# City of Franklin

### Historic Zoning Commission

Monday, May 11, 2026

**1 EAST ELEVATION**  
SCALE: 1/8" = 1'-0"

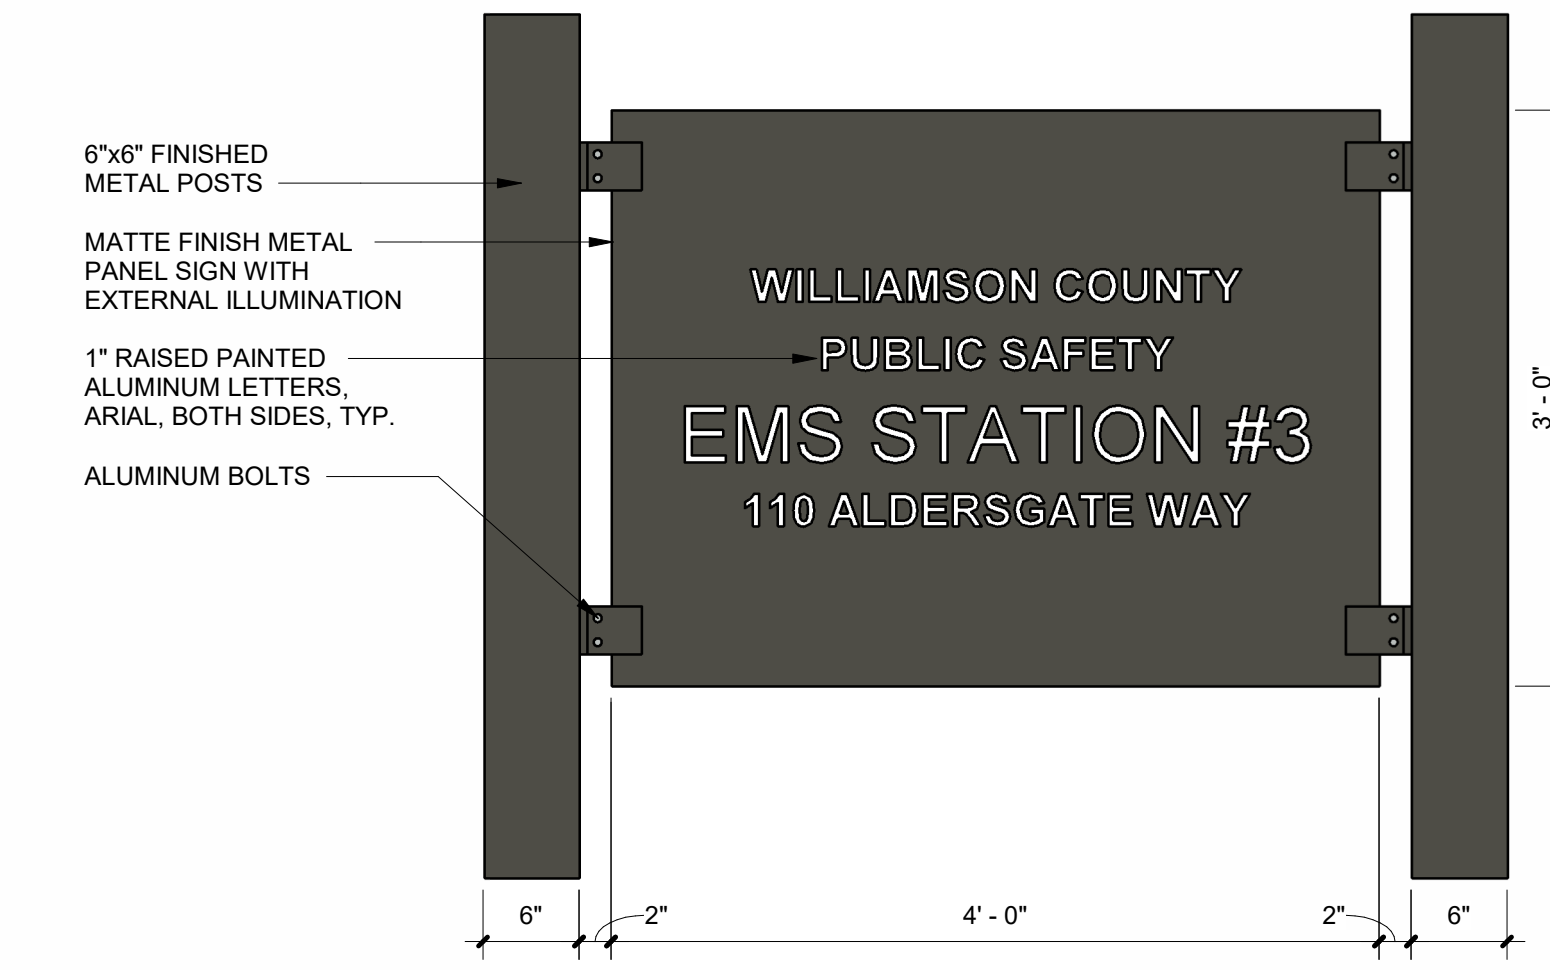
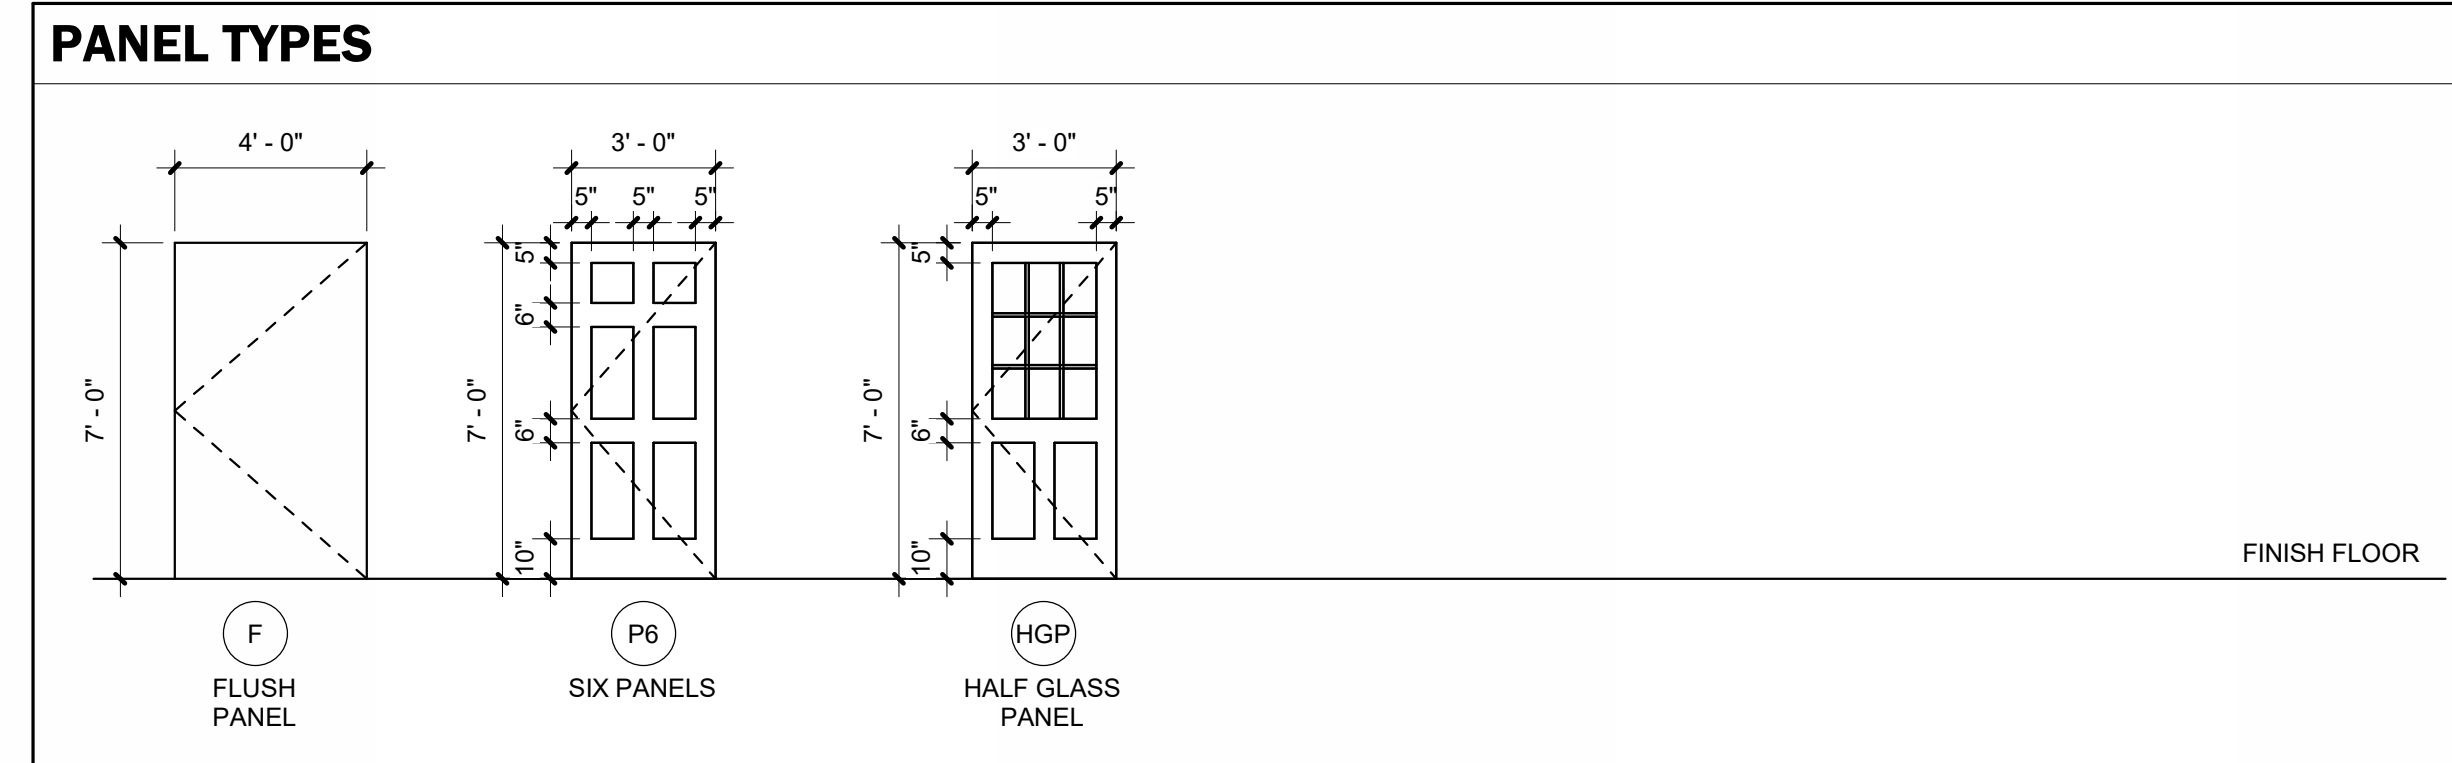
- Design new doors and doorways to be typical of historic civic buildings, including solid-to-void ratio, rhythm and spacing, and scale and intricacy.
- Provide casement, trim, and transoms or sidelights similar to those typically seen on historic civic buildings.

1. Windows shall use a true divided lite or a simulated divided lite to align with the Guidelines. Window specs shall be sent to the Preservation Planner for approval before building permit submittal.
2. The light fixtures shall use illumination with a warm white light.
3. The sign shall utilize a matte finish.
4. Screening for the generator is required and may qualify for an Administrative COA.
5. The application must meet all the requirements of the City of Franklin prior to issuance of a building permit.
6. Any additional changes to the approved plans must be returned to the Preservation Planner or the Historic Zoning Commission for review and approval.

OPTION 2 - FRONT RAMP

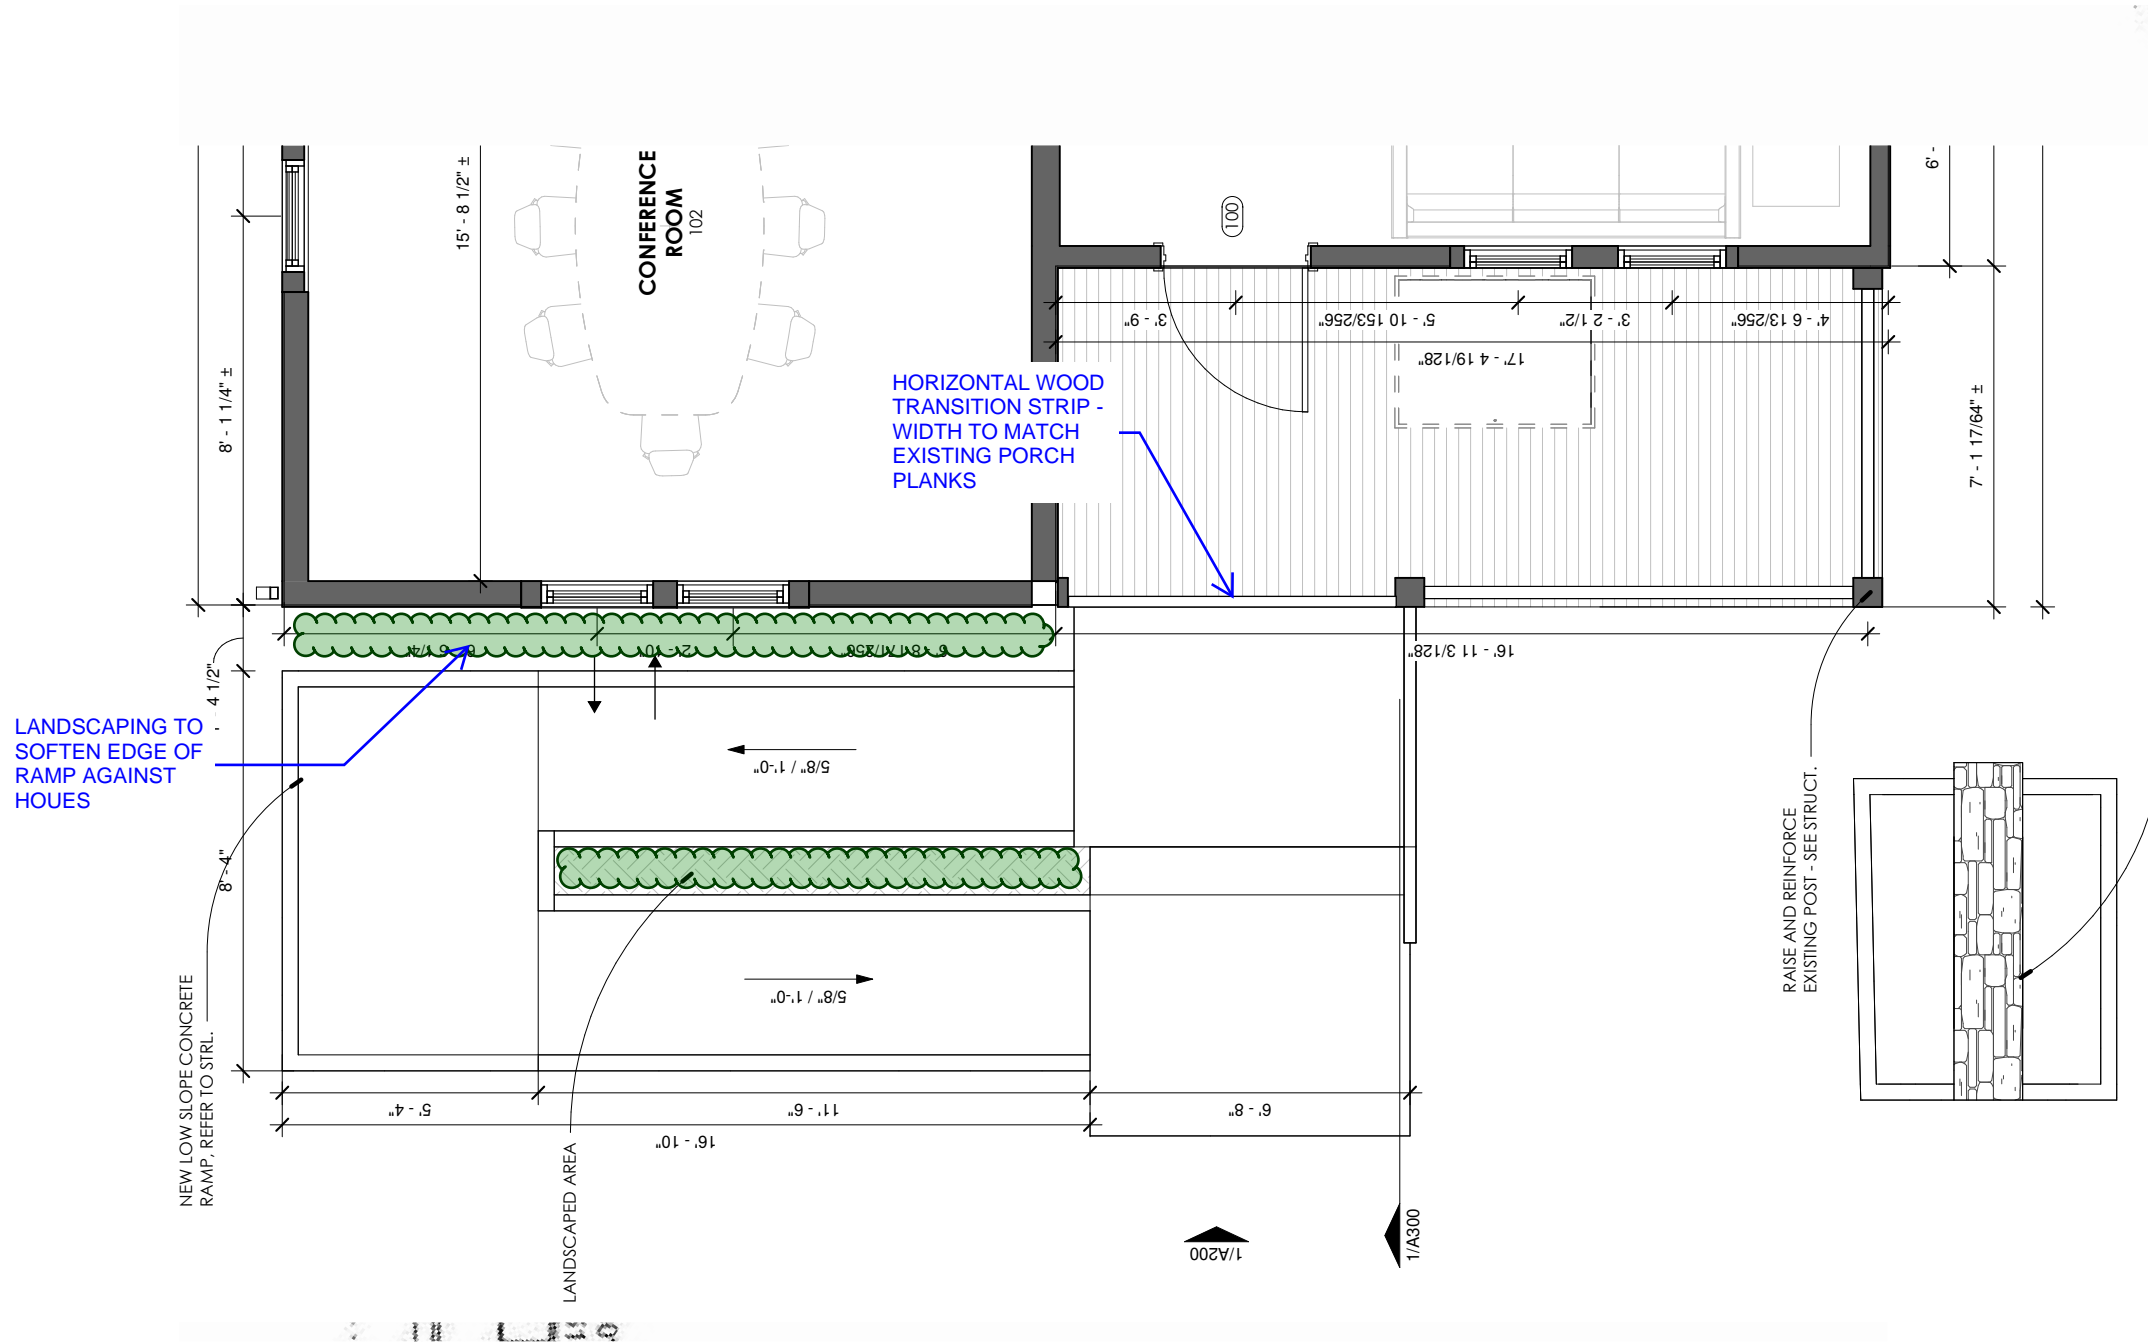
The proposed location of the ramp does not align with the Guidelines' recommendation for placing modern features in locations that are not readily visible; however, the position of the ramp appears to be the only feasible option for the site. Additional landscaping should be added between the sidewalk and the side of the ramp to help soften and screen the ramp.

1. Additional landscaping shall be provided between the sidewalk and the ramp, subject to approval by the Preservation Planner.
2. The application must meet all the requirements of the City of Franklin prior to issuance of a building permit.
3. Any additional changes to the approved plans must be returned to the Preservation Planner or the Historic Zoning Commission for review and approval.

**THE FACTORY AT FRANKLIN  
BUILDING 1 MECHANICAL SCREEN**

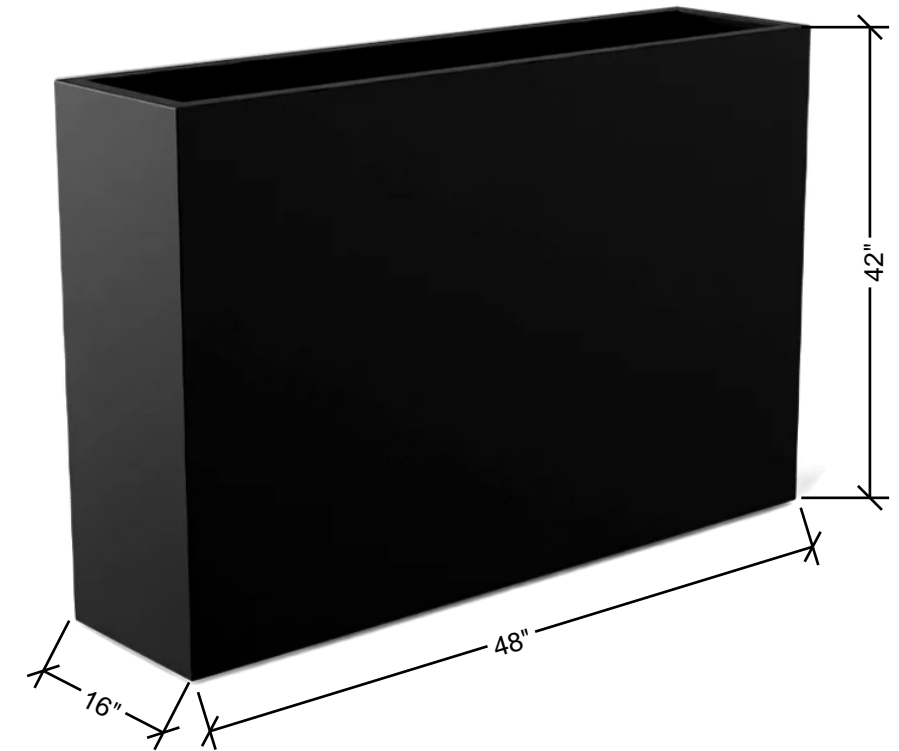
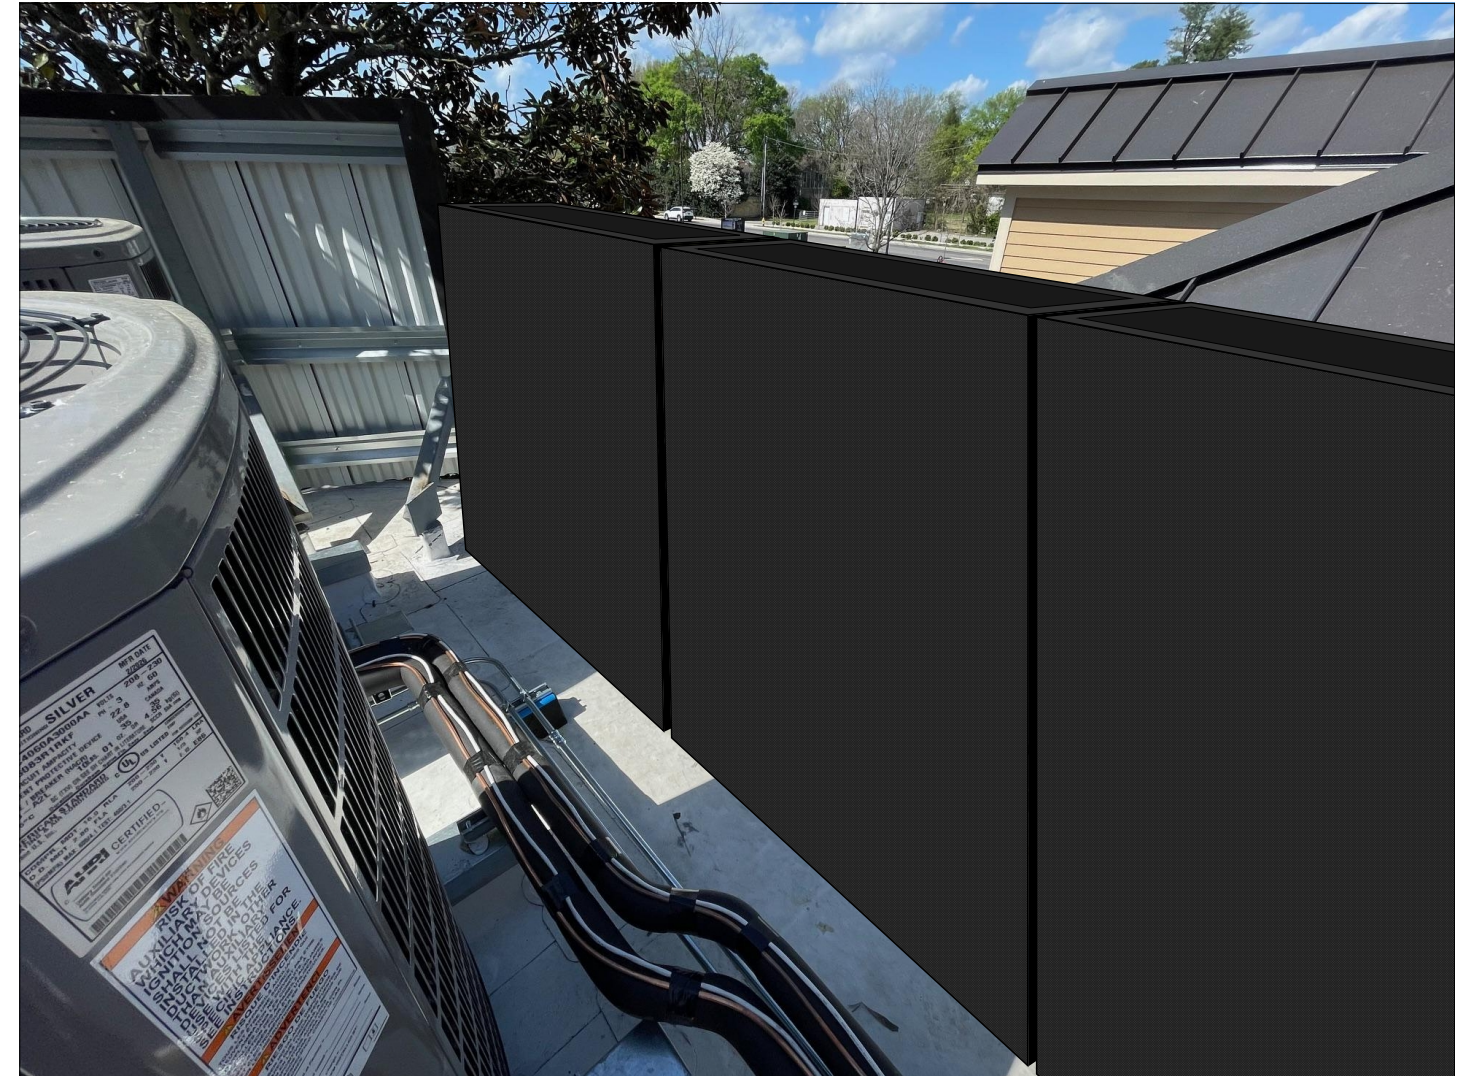
Screening the equipment is required by the Zoning Ordinance and is also recommended by the Guidelines. While the use of planters with foliage is not recommended per the Guidelines, it may be appropriate to use a metal planter in a matte finish without plantings to screen the equipment, provided the planter is sufficient to fully screen it.

1. The planter shall be a dark metal material with a matte finish.
2. The planter shall not utilize plant materials within the planter.
3. The planter shall be tall enough to meet the requirements within the Zoning Ordinance to fully screen the equipment.
4. The application must meet all the requirements of the City of Franklin prior to issuance of a building permit.
5. Any additional changes to the approved plans must be returned to the Preservation Planner or the Historic Zoning Commission for review and approval.
